CITY PLAN COMMISSION

FILE NUMBER: S234-151

REQUEST: An application replat 4.4493-acre tract of land containing all of Lot 1A in City Block 307 and a tract of land in City Block 497 to create one 1.4264-acre lot and one 3.0229-acre lot on property bounded by Oak Street, Swiss Avenue, Liberty Street and Live Oak Street.

PRELIMINARY PLAT
OF
LIBERTY STREET GARDEN AT THE MEADOWS FOUNDATION
LOTS 2A & 3A - BLOCK 497
BENB
4.4493 ACRES OF LAND OUT OF JOHN GROSSBY SURVEY - ABSTRACT NO. 495 CITY OF DALLAS, DALLAS COUNTY, TEXAS

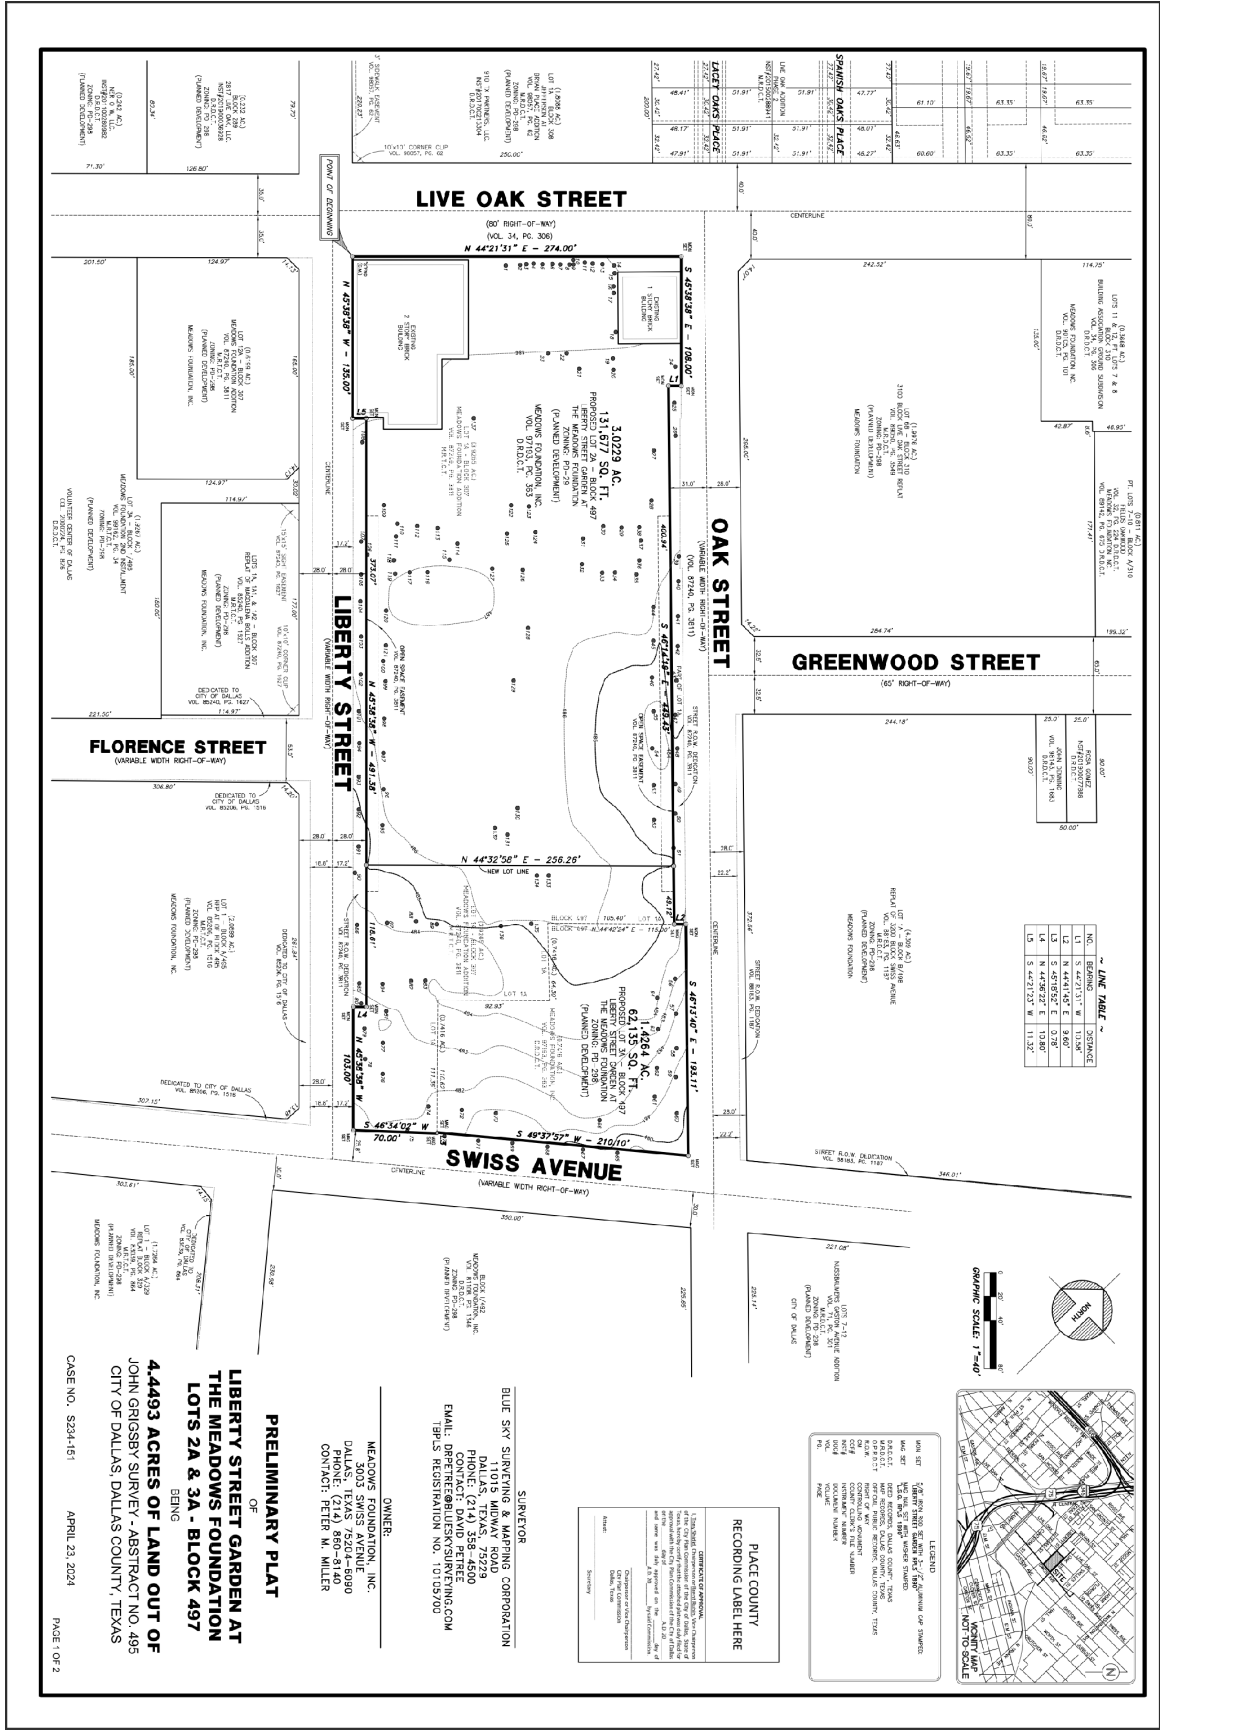
15. On the final plat, dedicate 28 feet of right-of-way (via fee simple or street easement) from the established centerline of Liberty Street & Oak Street. *Sections 51A-8.602(c), 51A-8.604(c) and 51A-8.611(c).*
16. On the final plat, dedicate a minimum 5-foot by 5-foot corner clip (via fee simple or street easement) at the intersection of Oak Street & Swiss Avenue. Section 51A 8.602(d)(1)
17. On the final plat, dedicate a minimum 5-foot by 5-foot corner clip (via fee simple or street easement) at the intersection of Swiss Avenue & Liberty Street. Section 51A 8.602(d)(1)
18. On the final plat, dedicate a minimum 5-foot by 5-foot corner clip (via fee simple or street easement) at the intersection of Liberty Street & Live Oak Street. Section 51A 8.602(d)(1)

19. On the final plat, dedicate a minimum 5-foot by 5-foot corner clip (via fee simple or street easement) at the intersection of Live Oak Street & Oak Street. Section 51A 8.602(d)(1)

21. Prior to final plat, submit a completed final plat checklist and all supporting documents.
22. On the final plat, show how all adjoining right-of-way was created. Section 51A-8.403(a)(1)(A)(xxii).
23. On the final plat, show distances/width across all adjoining right-of-way. Platting Guidelines.
24. On the final plat, show recording information on all existing easements within 150 feet of the property.
25. On the final plat, show all additions or tracts of land within 150 feet of the property with recording information. Platting Guidelines.
26. On the final plat, show or list the prior plat on the map, in the legal description, and/or title block. Platting Guidelines.
27. On final plat, address water line running through middle of tract.

31. On the final plat, change “Greenwood Street” to “Greenwood Street (FKA Florence Street)”. Section 51A-8.403(a)(1)(A)(xii).
32. On the final plat, identify the property as Lots 1B & 1C in City Block 307.
